RECOMMENDATIONS FOR V/STOL HANDLING QUALITIES

(WITH AN ADDENDUM CONTAINING COMMENTS ON THE RECOMMENDATIONS)

RECOMMENDATIONS FOR V/STOL HANDLING QUALITIES WITH AN ADDENDUM CONTAINING COMMENTS ON THE RECOMMENDATIONS

An Addendum now included with the Report contains comments from various sources on the Recommendations.

Fig. 1a

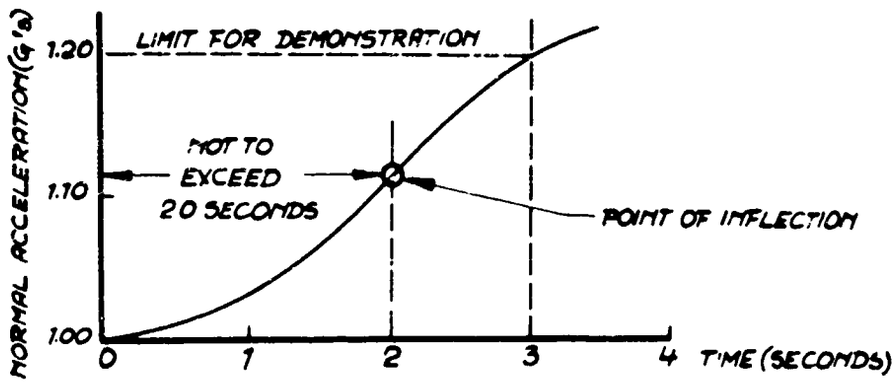
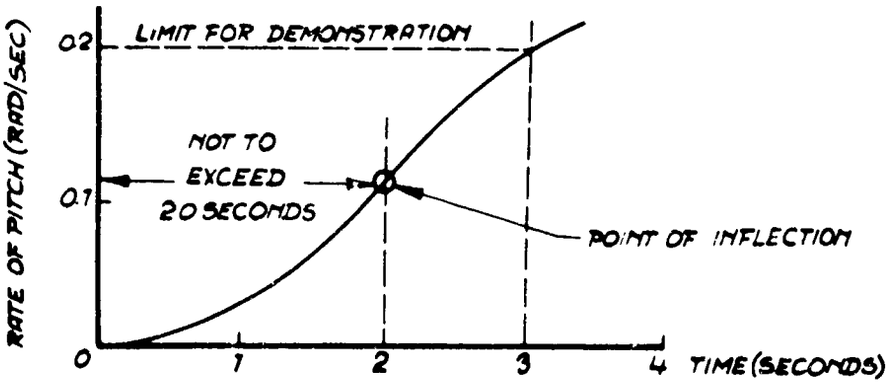
31. Case of initial negative g is not covered. This type of response is characteristic of delta aircraft.

Fig. 2

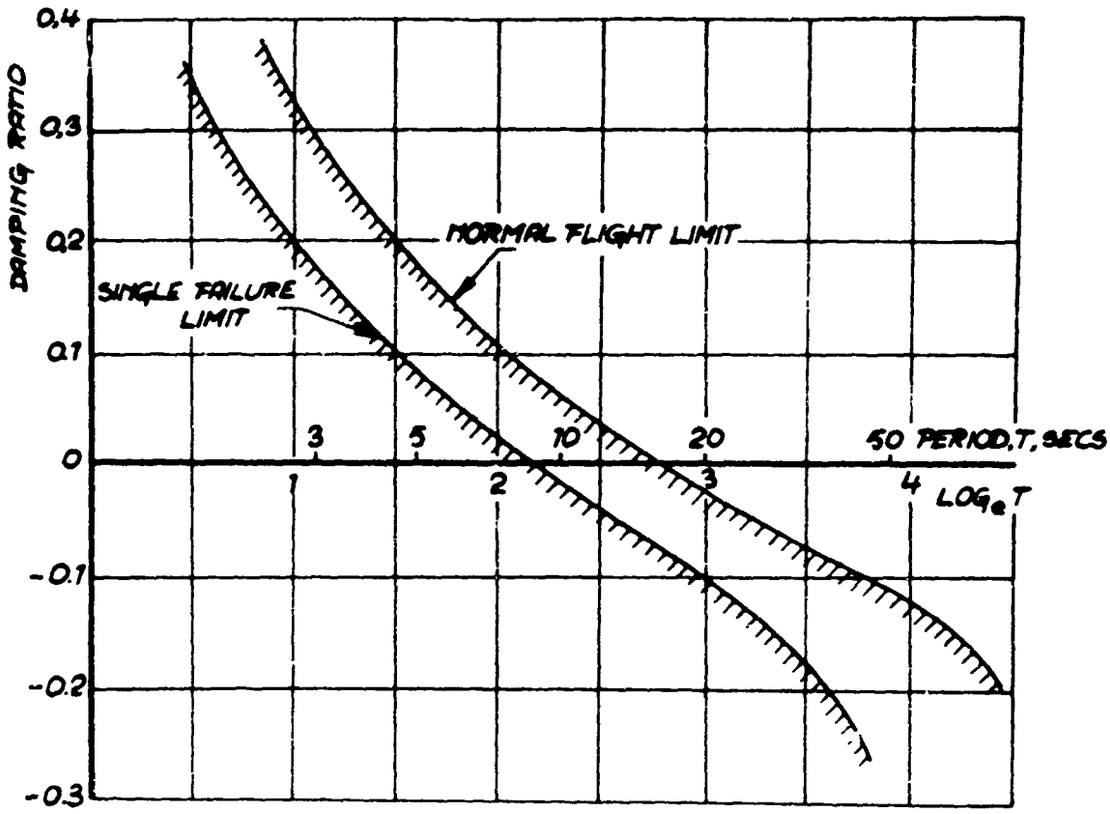
34. For conventional ILS approaches, longitudinal short-period oscillations in the 5-15 sec range are a problem area. In this range an increase in damping is required. Possibly this effect is more prominent in conventional flight because of stronger g-response. Nevertheless the present recommendation seems an oversimplification.

34. Recent tests at our establishment suggest the damping ratios specified do not appear adequate even for visual approaches. For example, our tests suggest the damping ratio should be about 0.4 for a 12-second period, but in general our results showed that the damping requirements were primarily related to the gust response. If the damping was sufficient to adequately reduce the gust response, the damping ratio of the oscillatory mode (directional) was much higher than that given by Figure 2.
